Re: Zircaloy Clad  
Conversion  
ISAP Topic 2.17

Haddam Neck Plant  
Additional Information  
Small-Break Loss of Coolant Accident Analysis--  
Zircaloy Clad Fuel

Attachment  
Haddam Neck Plant  
Additional Information

FIGURE 1-1  
HADDAM NECK PLANT ZIRCALOY SBLOCA  
NUREG-0630 RUPTURE TEMPERATURE VS.  
NULAP-5 PEAK CLAD TEMPERATURE  
HOT ROD 1ST UPPER NODE OF 24

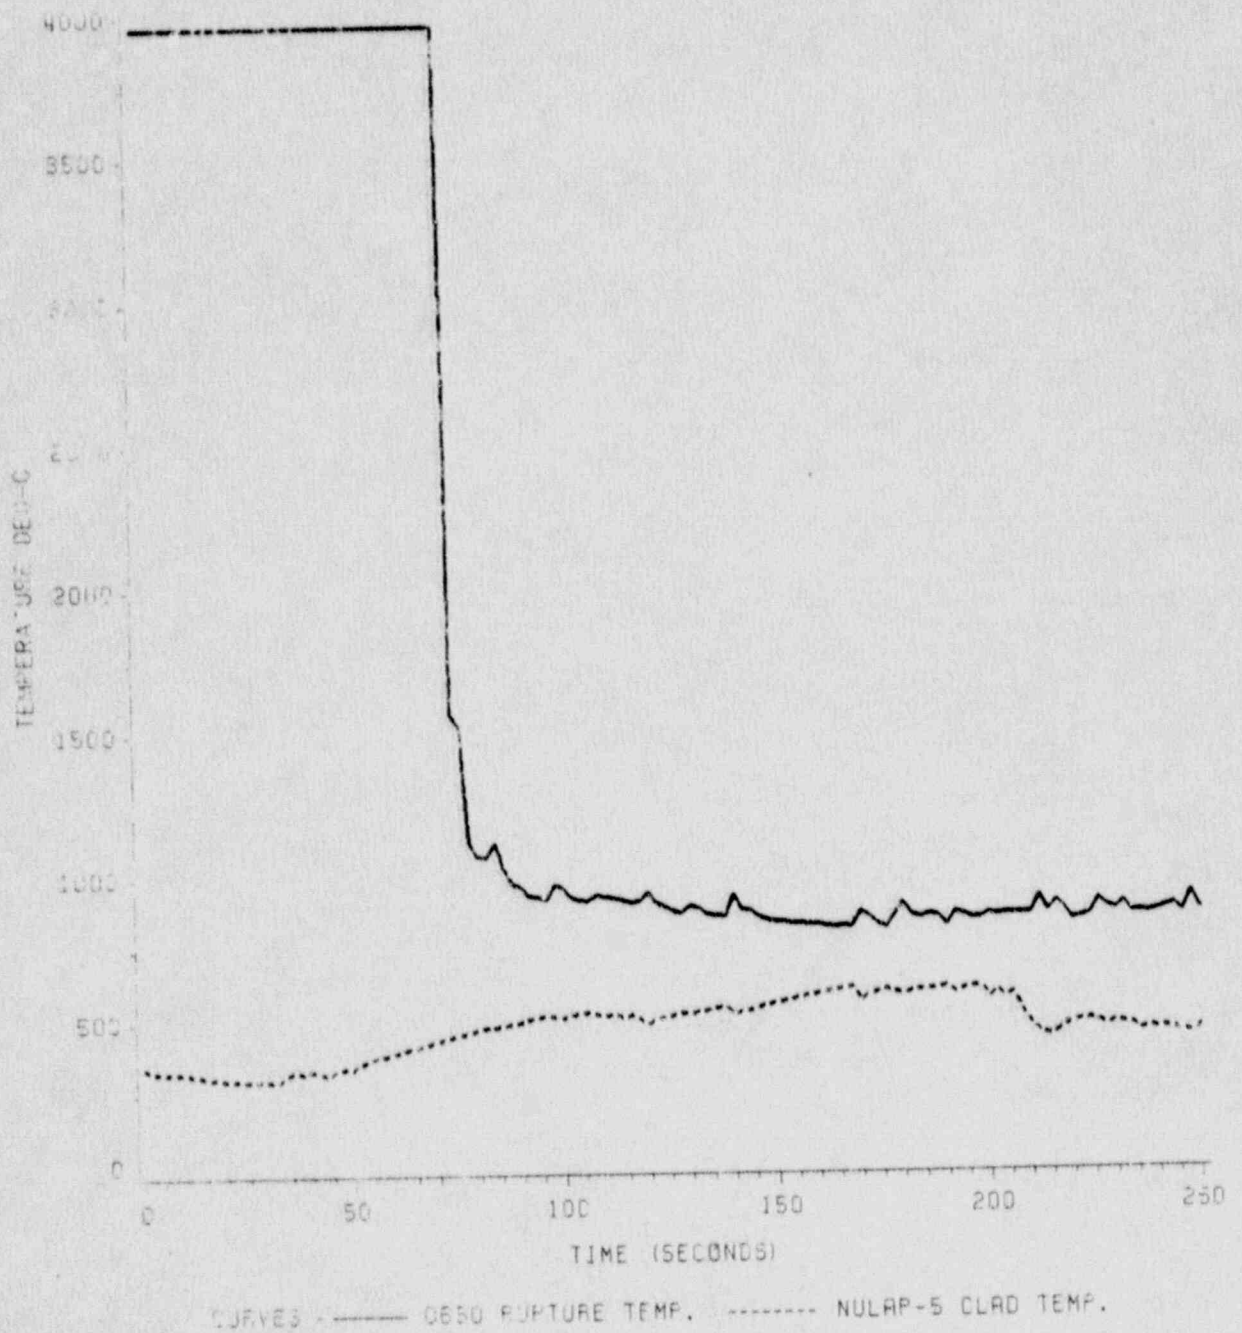
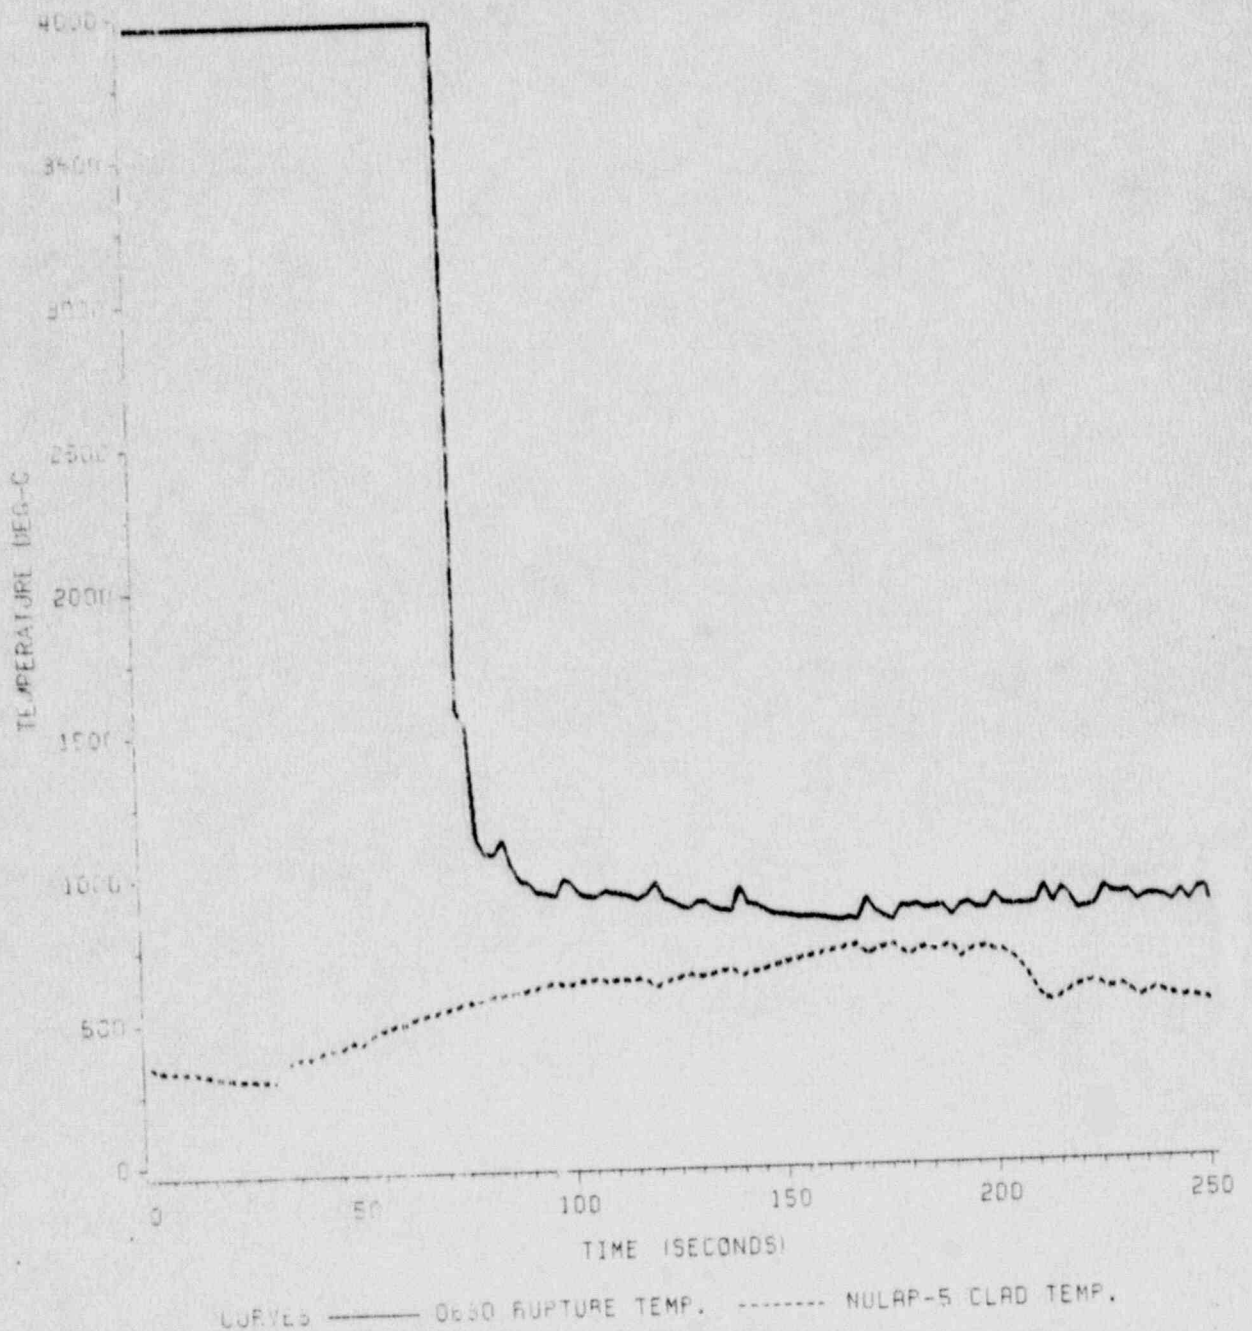
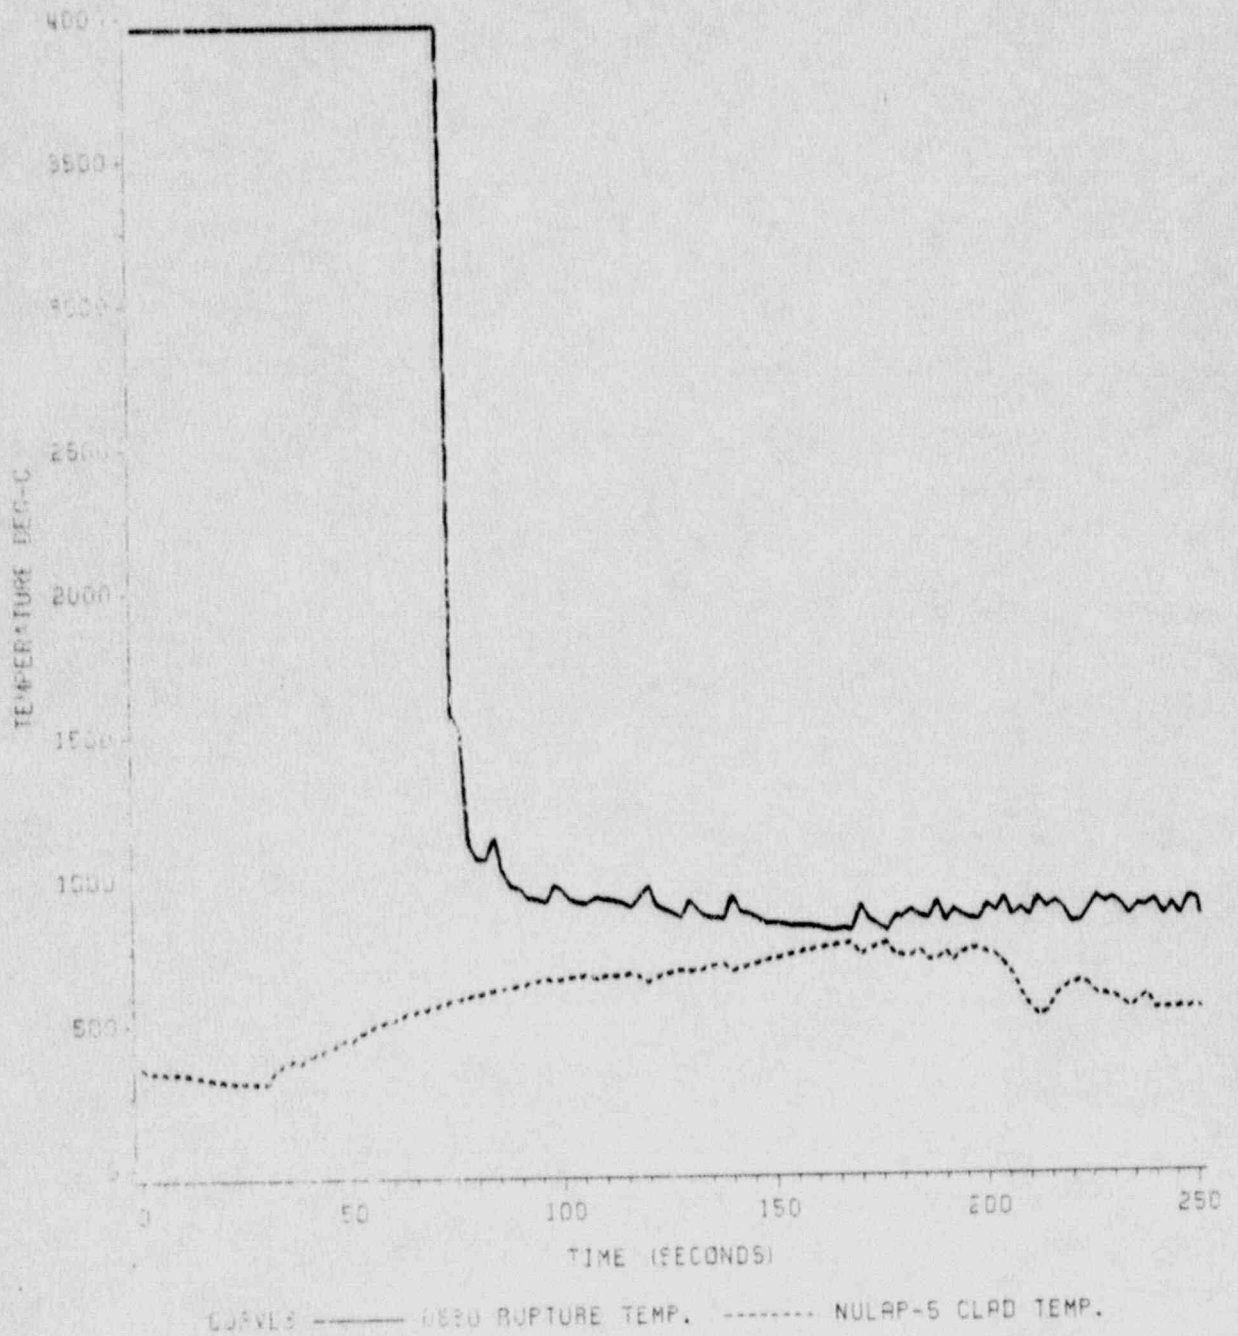
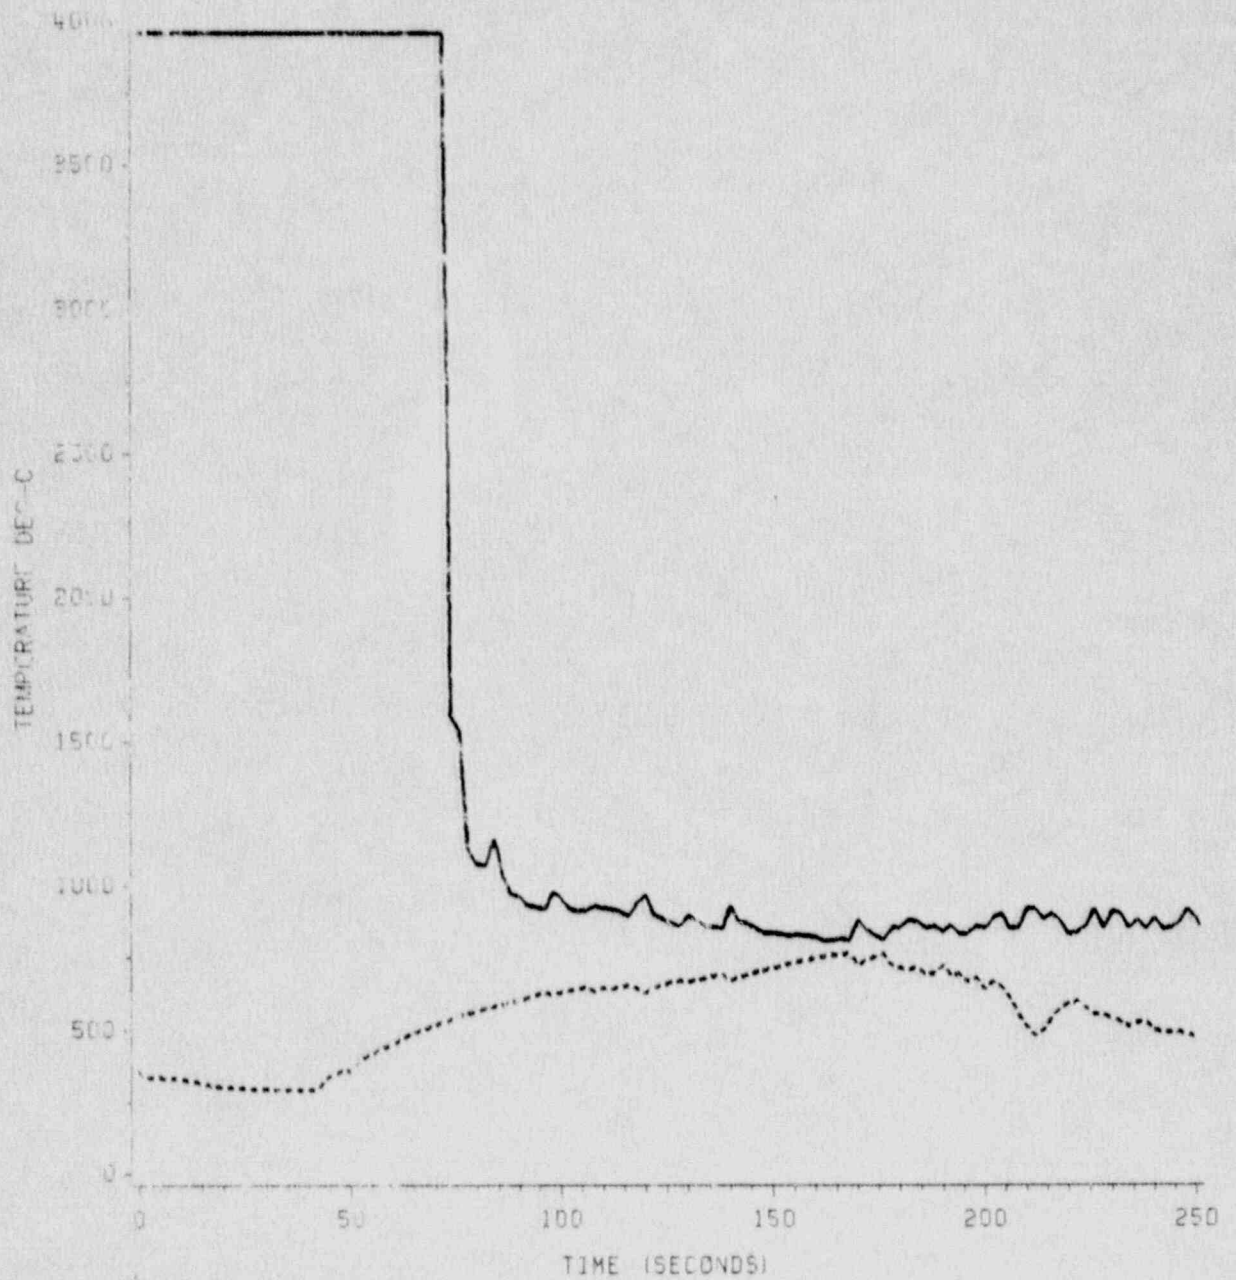
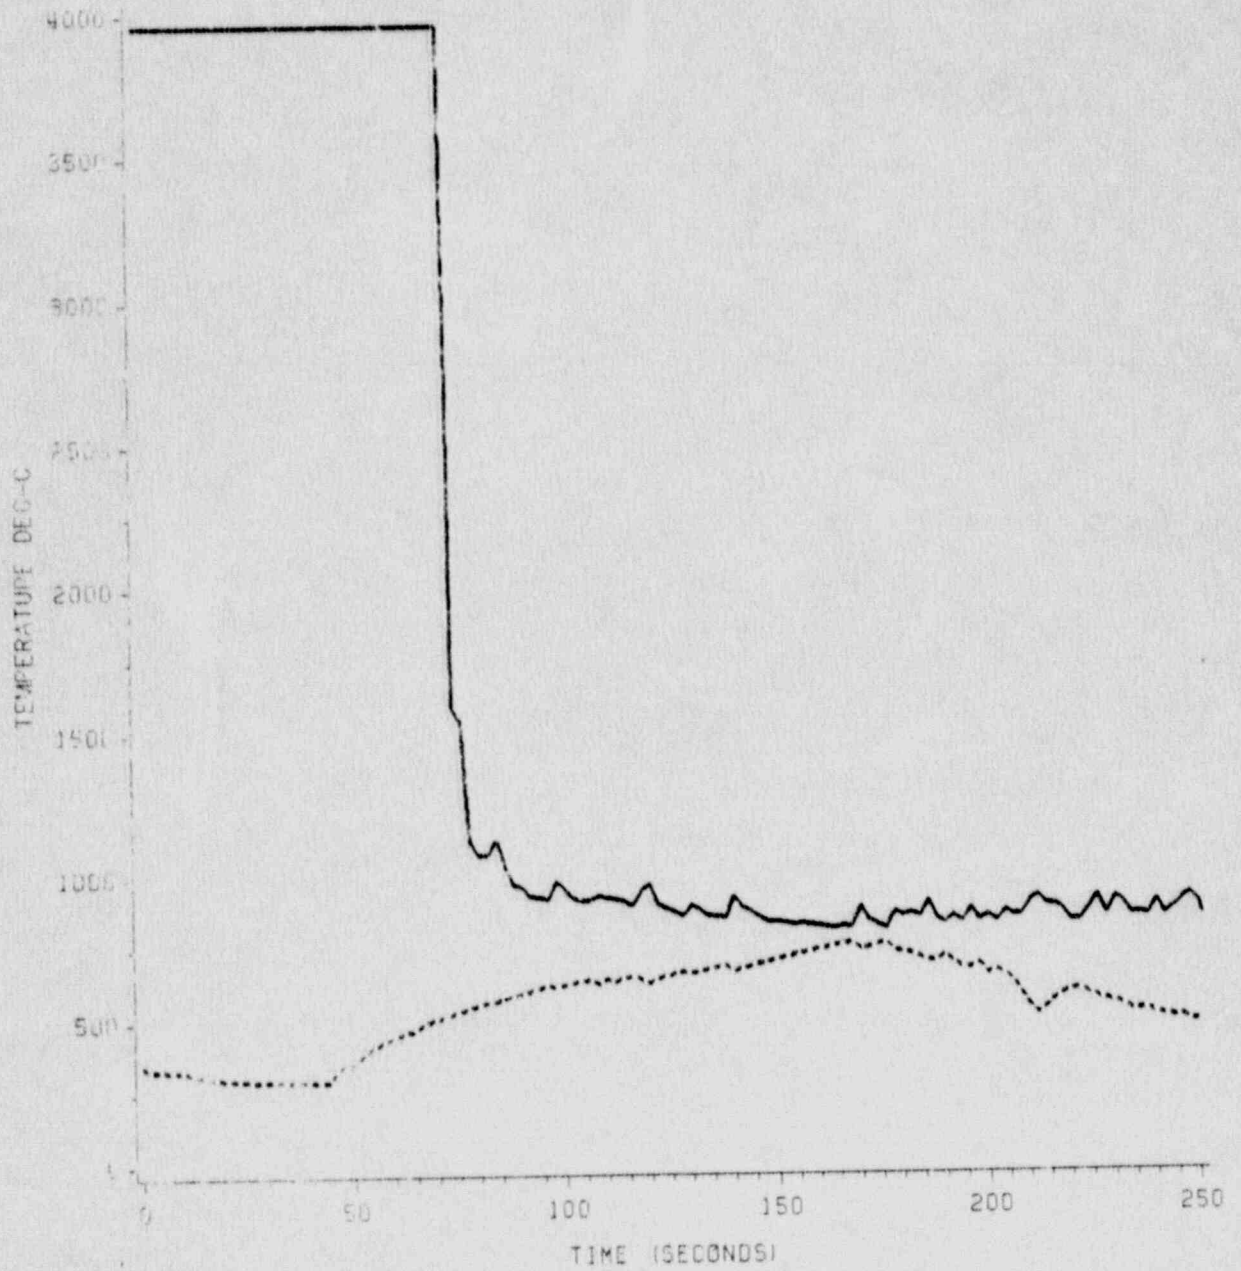
NUREG 0630 provides information regarding the zircaloy-clad material and deformation behavior for use in ECCS licensing analyses. Demonstrate that the clad behavioral model in NULAP5 is consistent with or conservatively bounds the data in NUREG 0630.

The clad behavior model in NULAP5 conservatively bounds NUREG 0630 for the NUSCO 163 break spectrum. The 0.4 ft<sup>2</sup> break was the maximum cladding temperature case (1410 degF) and the only case for which any swelling was calculated to occur by the NULAP5 method. The 0.4 ft<sup>2</sup> case has been repeated, imposing NUREG 0630 methods for calculating rupture. NUREG 0630 Equation 3-2 for TR, rupture temperature, and 3-1 for hoop stress were solved throughout the transient using NULAP5 transient data for clad differential pressure and heating rate. As shown in the attached 7 figures of clad temperature and rupture temperature vs. time for the top 7 of 24 hot rod nodes, NUREG 0630 rupture conditions are never achieved. NUREG 0630 deformation in the form of reduction of flow area follows only from rupture. Thus, using the NUREG 0630 data, no swelling would be predicted. Therefore, any calculation of swelling, as NULAP5 did calculate for the 0.4 ft<sup>2</sup> break, conservatively bounds NUREG 0630 data.
